City of Woodburn
Community Development

Memorandum

Date: February 24, 2023
To: Melissa Gitt, Building Official
Cc: Alyssa Nichols, Permit Technician
Dago Garcia, P.E., City Engineer
Jeff Bolton, Multi/Tech Engineering
From: Colin Cortes, AICP, CNU-A, Senior Planner *cc.*
Subject: **Building permits 971-23-000066-STR etc. Woodburn Place West Apts.
Planning Division review**

On behalf of the Planning Division, I reviewed the building permit application site plans for which I was assigned review January/February 2023 for conformance with the [Conditional Use CU 22-01](#) land use final decision conditions of approval and notes to the applicant related to Woodburn Place West Apartments at 2045 Molalla Road (applicant's job # 7402).

- Land use review sheet C1.3 site plan marked (shifted bicycle parking pads in blues)

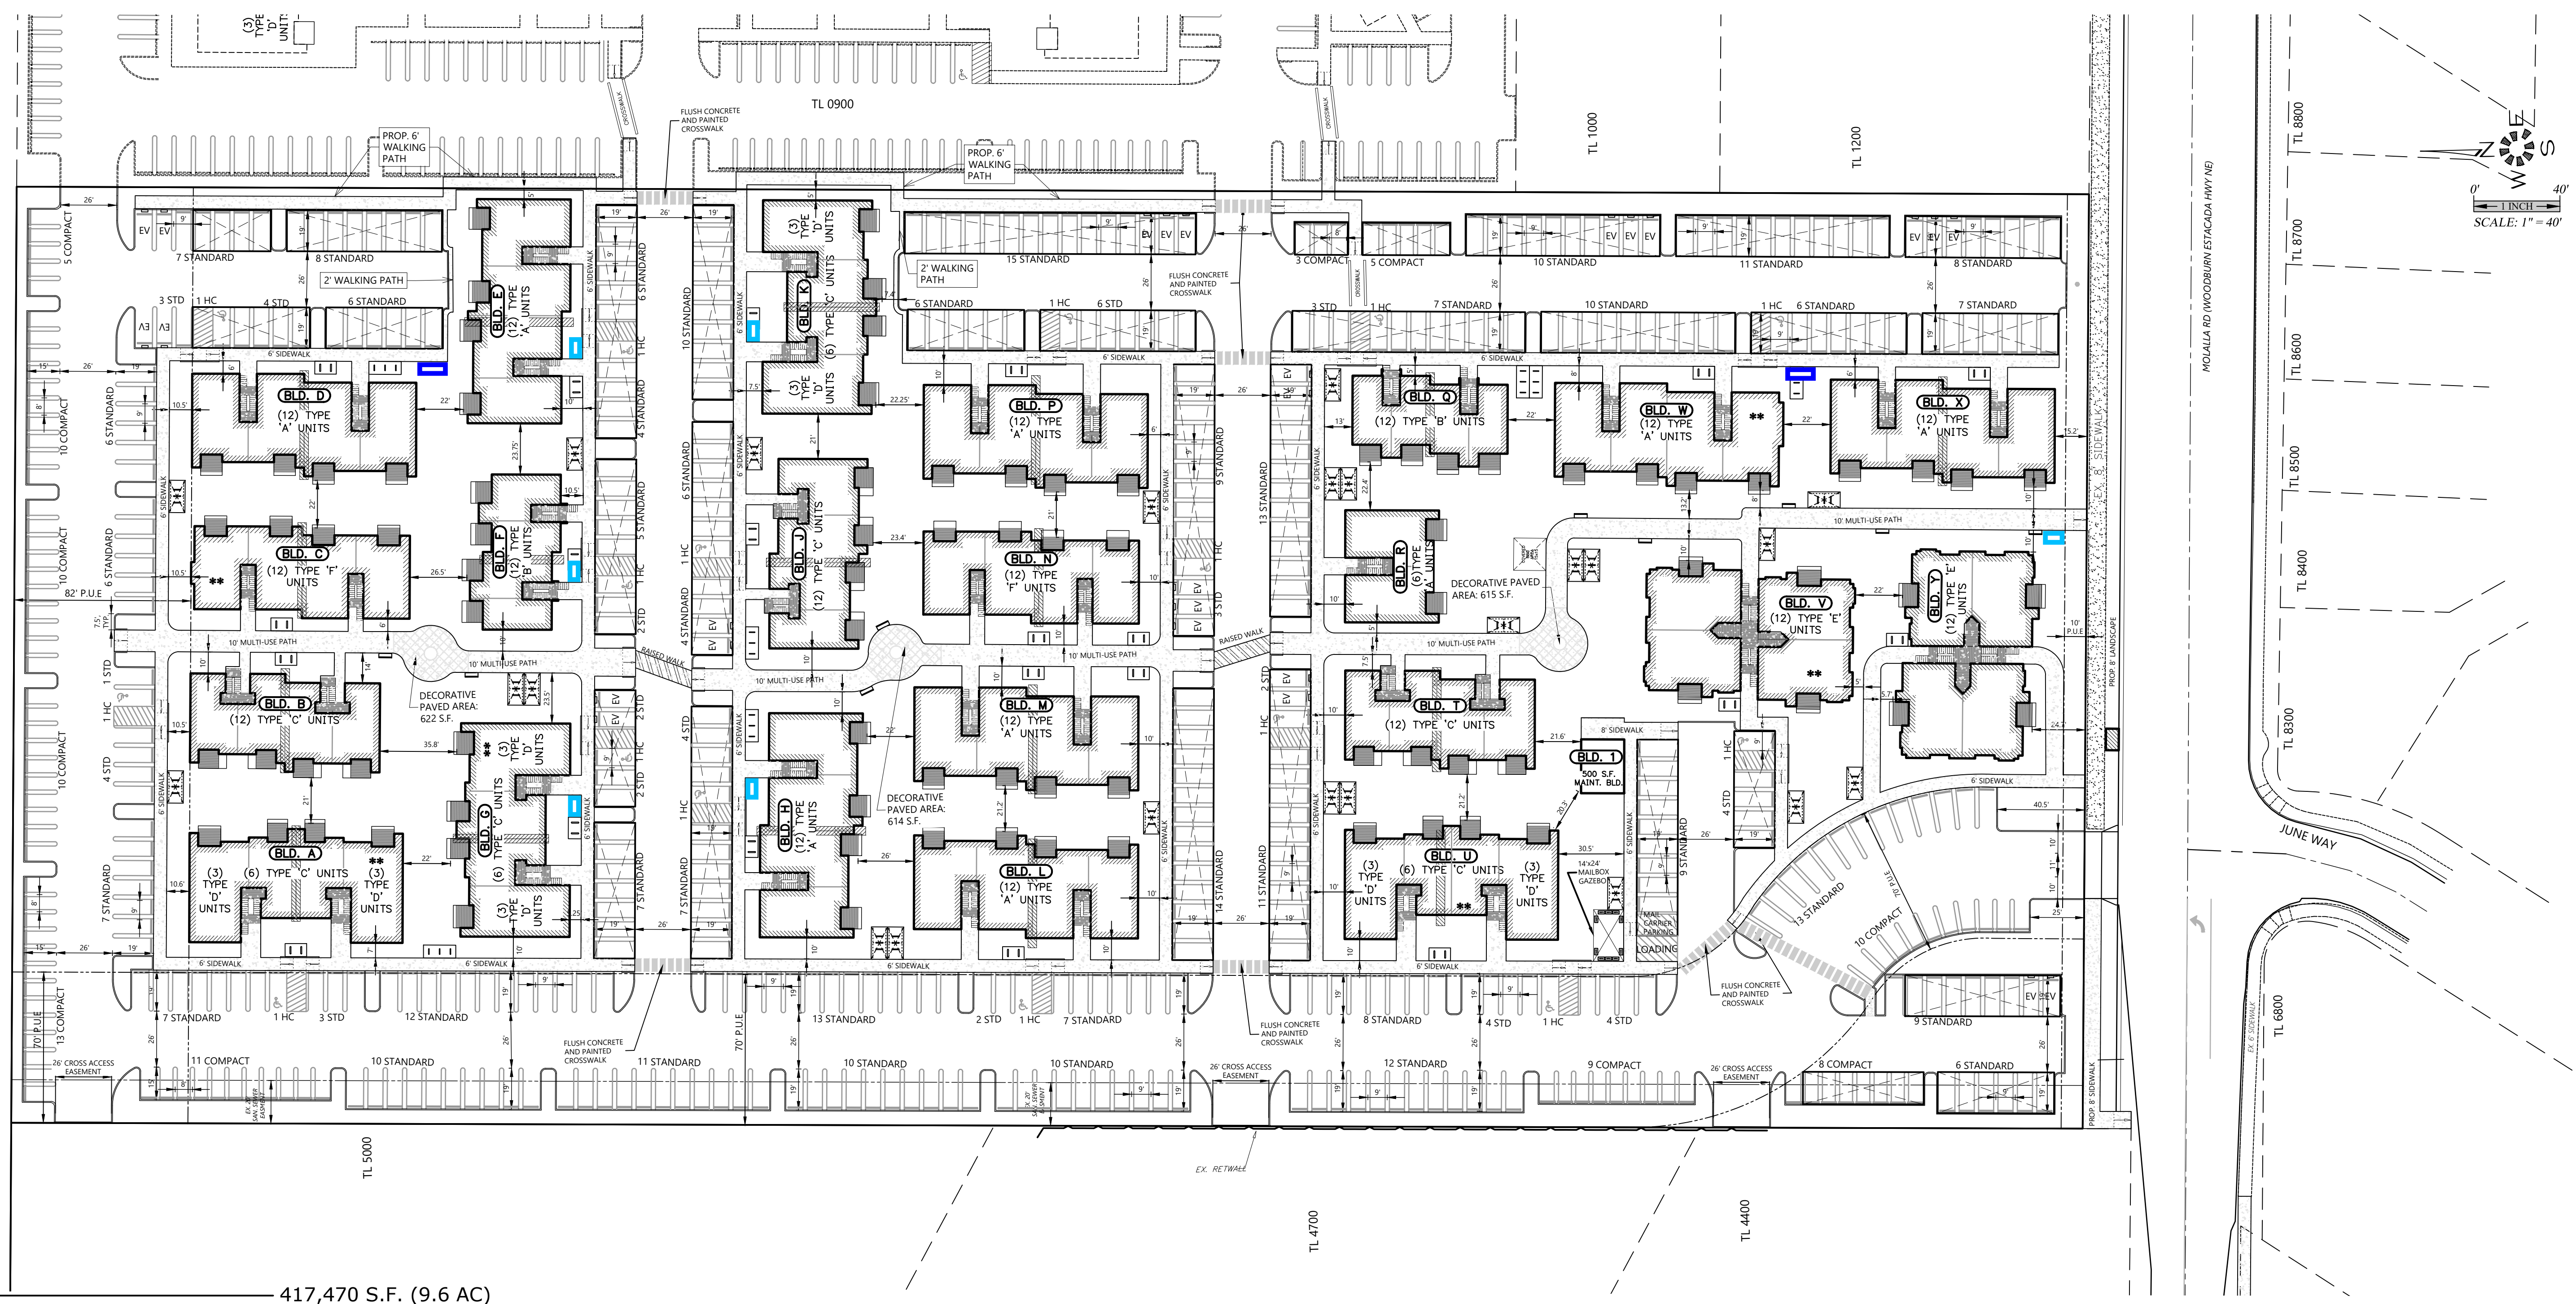
1. CU5a:
 - a. Revise a details sheet to provide the hook spec to confirm that the model is foldable or retractable.
 - b. Revise the site plan Sheet C1.3 bottom right note about outdoor closet bicycle parking to confirm that closets are large enough per Table 3.05G (6' high, 1'-6" wide, and 3'-4" deep) with hooks sited accordingly.
2. CU5c: Is it relevant and if so is it met?
3. CU5d: Revise Sheet C1.4 outdoor bicycle parking shelter spec to be min vertical clearance 8 ft.
4. Shifts: Please shift a few of the unsheltered outdoor rack pads to blue locations per Attachment 1, a marked copy of the land use review site plan. (I had no PDF of the slightly different site plan submitted for building permit review.) Compare with the building permit site plan to understand the shifts.
